TECHNICAL BULLETIN — October 2015

400. Hydraulic cylinder problems

Issuing Entity:	Bulletin No.: SB-033_01
Vekoma Rides Parts & Services B.V.	Release Date: 19-03-2015
Schaapweg 18	Effective Date: immediately
6063 BA VLODRUP	Supersedes: N.A.
The Netherlands	Completion Date: within 4 weeks fter release of this Bulletin
CoC Number: 12049585

Service Bulletin

Figure 3: information for LE32 and LE25 screw connection at the bottom.

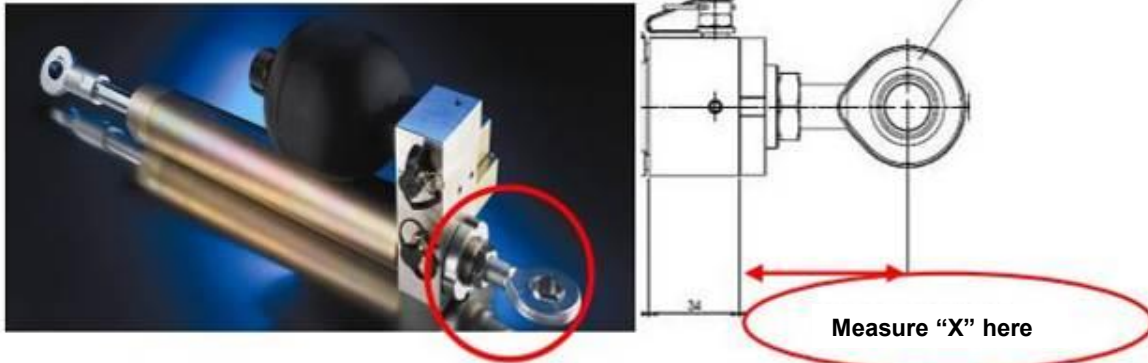
The following data apply for all LE32 versions:

For the LE 32 versions the screw thread depth is correct when the rod end length “X” is below 65 mm. ($X < 65\text{mm}$)

The following data apply for all LE25 versions:

For the LE 25 versions the screw thread depth is correct if the rod end length “X” is below the value as stated behind the product number in de table below. The small x at the end of the product number indicates the version number.

We recommend that the joint rod heads be secured at the specified dimensions and tightened with a torque wrench. The LE 25 version should be tightened to **80 Nm ±10 Nm**. The LE 32 version should be tightened to **90 Nm ±10 Nm**.

The correct measurement must be set and checked when installing or performing maintenance on the Cylinder Accumulator unit. In this way the required minimum screw thread depth engagement (as set out in VDI 2230) is maintained.

This example image is for reference of dimension X only.

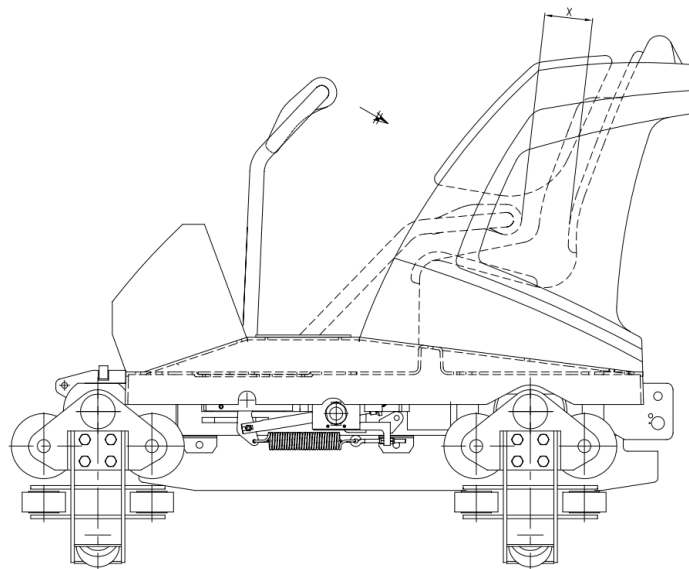
The cycle test is a test which provides information about the functionality of the HLU and the scale of the contaminations. The cycles test has to be performed 1050 times. After completion of 200 cycles succesfully, the ride can be taken into operation with passengers.

1. Close the restraint, make sure the right hand side HLU is only locking the restraint;
2. Measure the minimal distance (X) between the restraint and the seat (only at start of test);
3. Log this dimension for every seat (only at start of the test);
4. Wait for 10 seconds;
5. Measure the minimal distance (X) between the restraint and the seat;
6. In case this dimension increased by 2 cm the HLU failed and needs to be replaced immediately by a HLU which passed the 1050 cycles;
7. If no dimension change was noticed proceed with step 1;
8. Keep repeating this procedure until 200 cycles have passed the test procedure;
9. Repeat this test and make sure the left hand side HLU is only locking the restraint;
10. After completion of the 200 cycle test for the left and the right HLU it is allowed to take the vehicle in operation.

1. Close the restraint
2. Measure the minimal distance (X) between the restraint and the seat (only at start of test);
3. Log this dimension for every seat (only at start of the test);
4. Wait for 10 seconds;
5. Measure the minimal distance (X) between the restraint and the seat;
6. In case this dimension increased by 2 cm the HLU failed and needs to be replaced immediately by a HLU which passed the 1050 cycles;
7. If no dimension change was noticed proceed with step 1;
8. Keep repeating this procedure until 200 cycles have passed the test procedure;
9. After completion of the 200 cycle test for the single HLU it is allowed to take the vehicle in operation.
